Memorandum

From John N. Fox,
Chief Petroleum Engineer
Petroleum Branch

Subject **Viriden Roselea Unit No. 1**
Well Licence Applications

PLAN OF WELL SITE LOCATION
CHEVRON VIRDEN ROSELEA UNIT # 1
LSD. 13B ,SEC. 21 ,TP. 10 ,RGE. 25 W.P.M.
MANITOBA

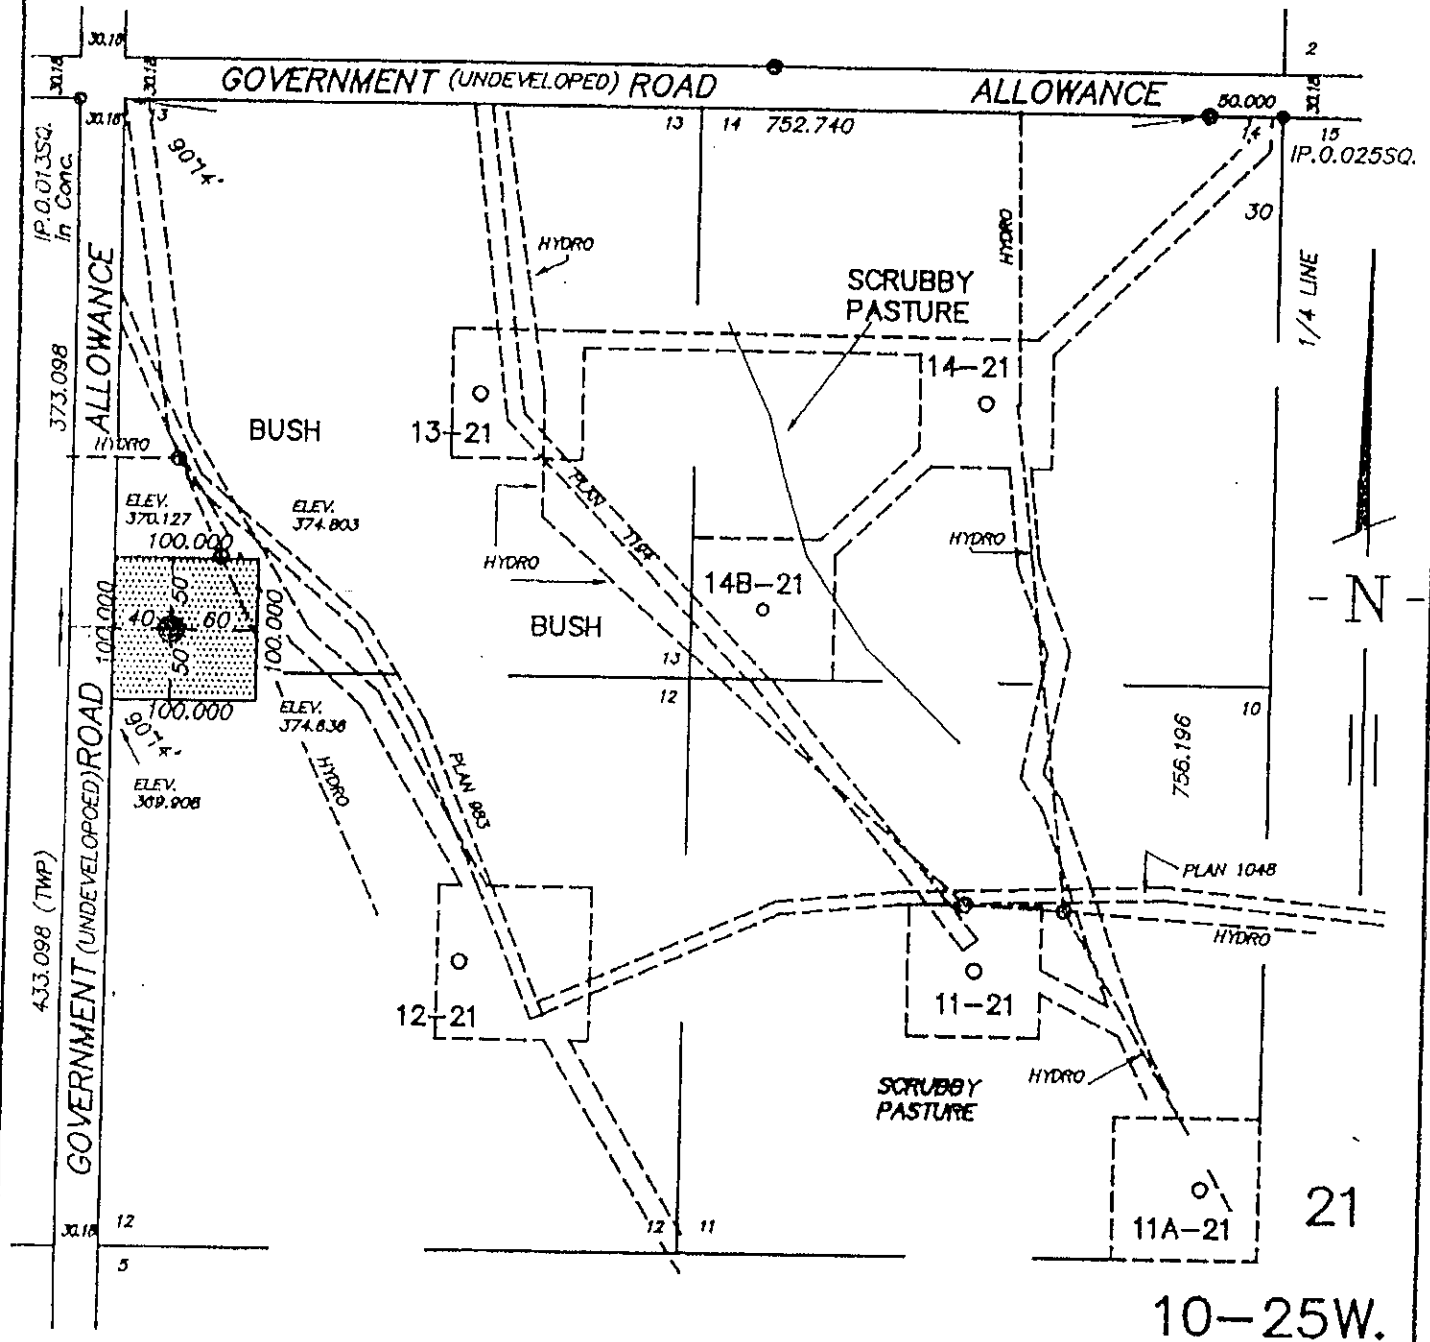
The sites have been reviewed by our Petroleum Inspectors and they have no concerns. There is a 4m drop east to west across the 13B-21 lease. The lease will be dyked to ensure there is no run-off of fluids from the wellsite. The 1A-29 well has been moved off the side slope of the river valley and poses no concerns. The 1B-29 and 1C-29 locations are in crop land on the floor of the Assiniboine valley.

PLAN OF WELL SITE LOCATION CHEVRON VIRDEN ROSELEA UNIT # 1 LSD. 1B ,SEC. 29 ,TP. 10 ,RGE. 25 W.P.M. MANITOBA

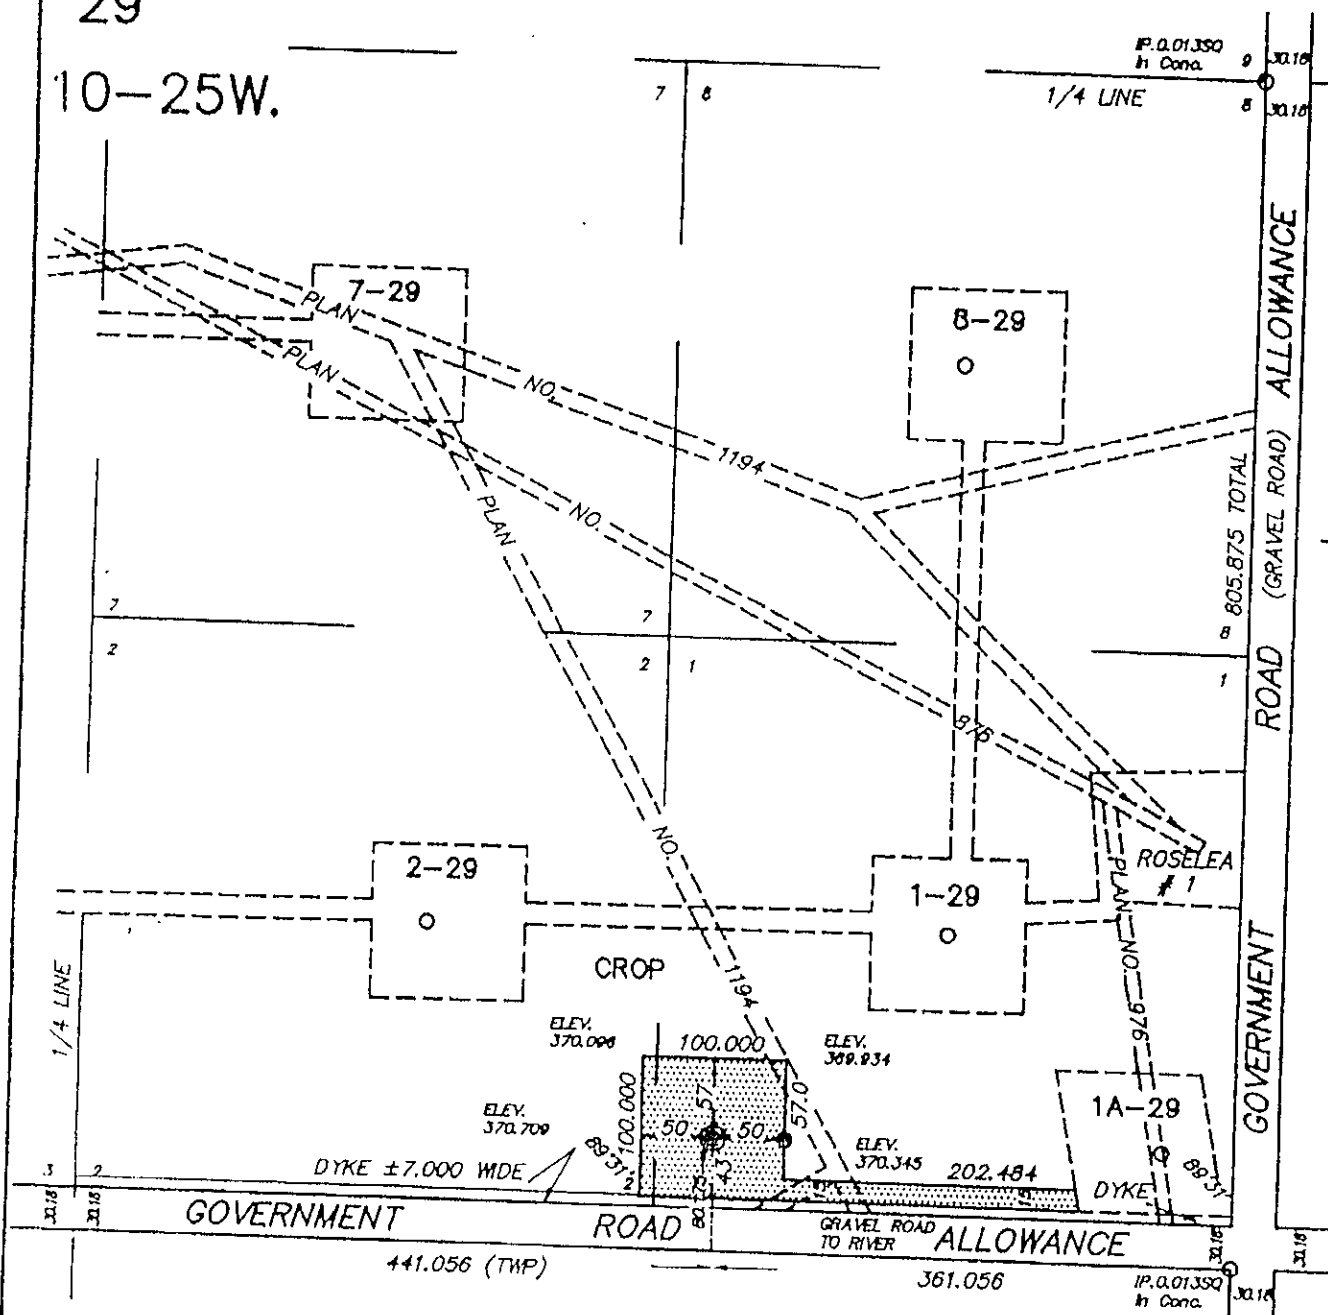
Chevron has made application for five more well licences in Viriden Roselea Unit No. 1. I'm forwarding you a copy of the surveys for the five locations 13B-21-10-25 (WPM) (Well #2), 4C-28-10-25 (WPM) (Well #8), 1A-29-10-25 (WPM) (Well #7), 1B-29-10-25 (WPM) (Well #9) and 1C-29-10-25 (WPM) (Well #13).

PLAN OF WELL SITE LOCATION **CHEVRON VIRDEN ROSELEA UNIT # 1** LSD. 14B ,SEC. 21 ,TP. 10 ,RGE. 25 W.P.M. MANITOBA

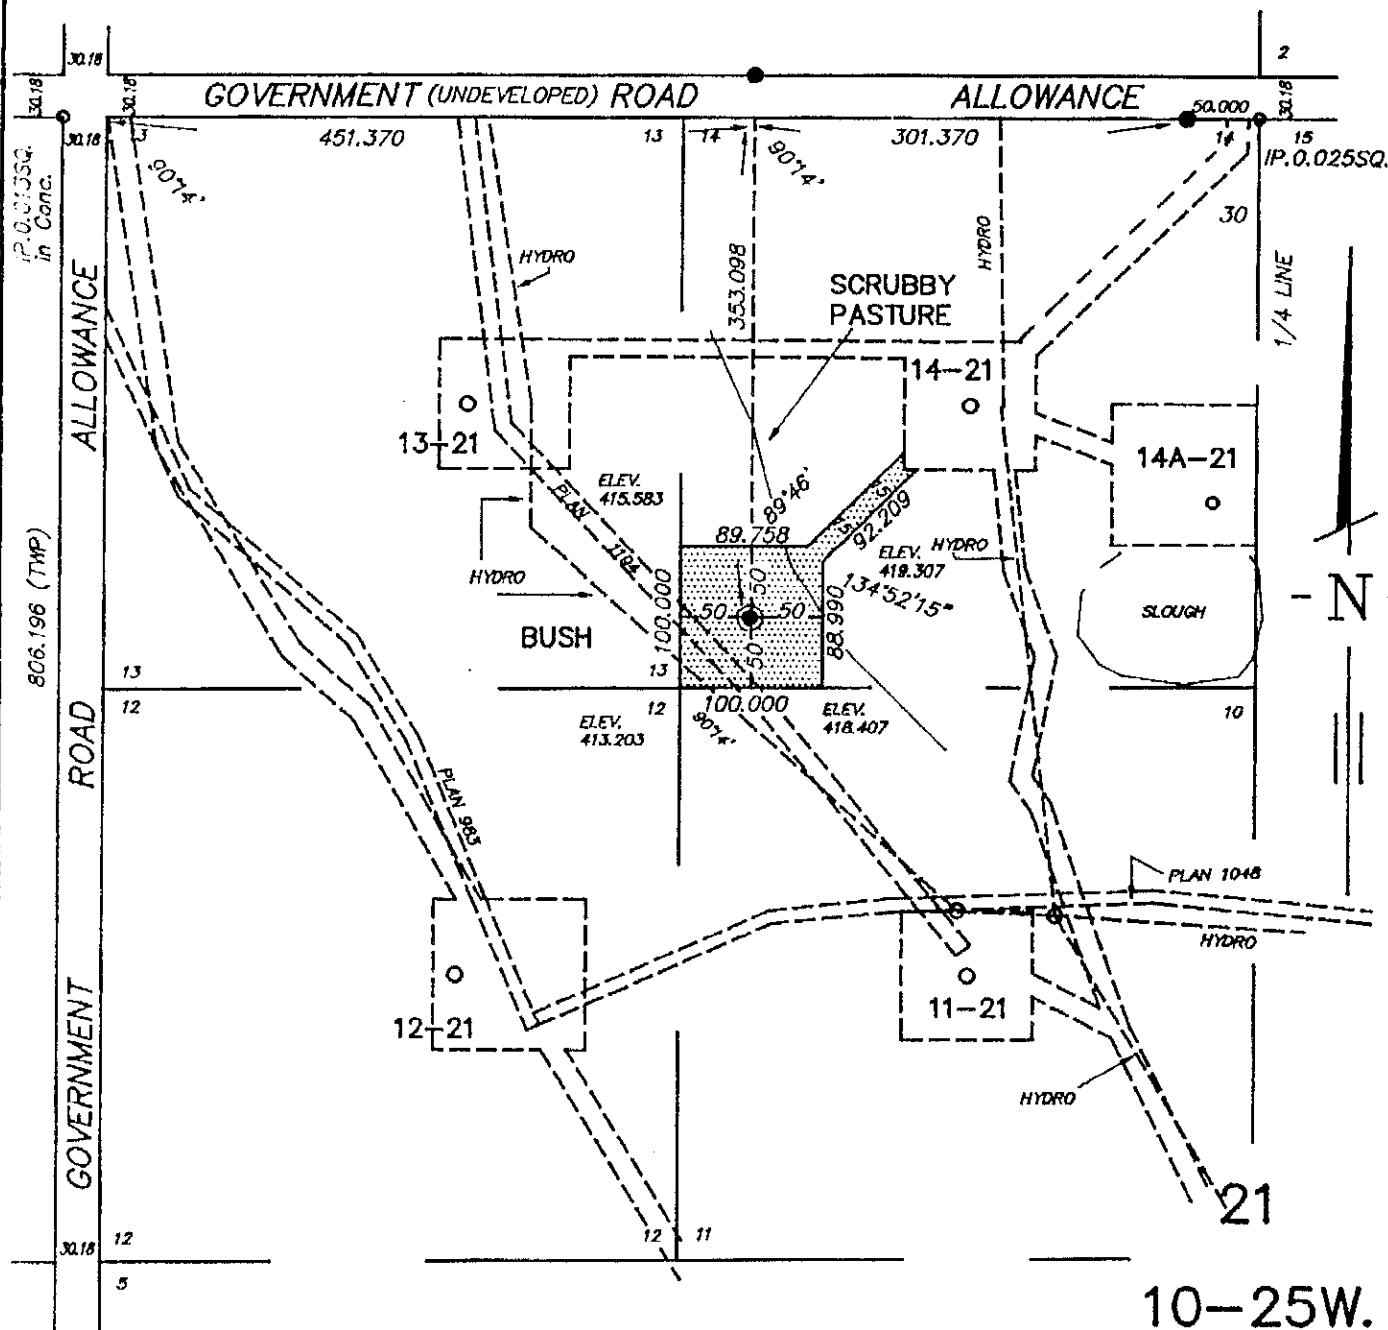
✓ 4. Chevron VRU No. 1 14 B - 21-10-25 WPM ✓ drill east of access road between 11-21-10-25
Pasture: extremely rocky, located near edge of slope. Will need to minimize disturbance of natural vegetation, construct a contoured berm around the well site to divert run-off water and re-vegetate the well site including the berm.
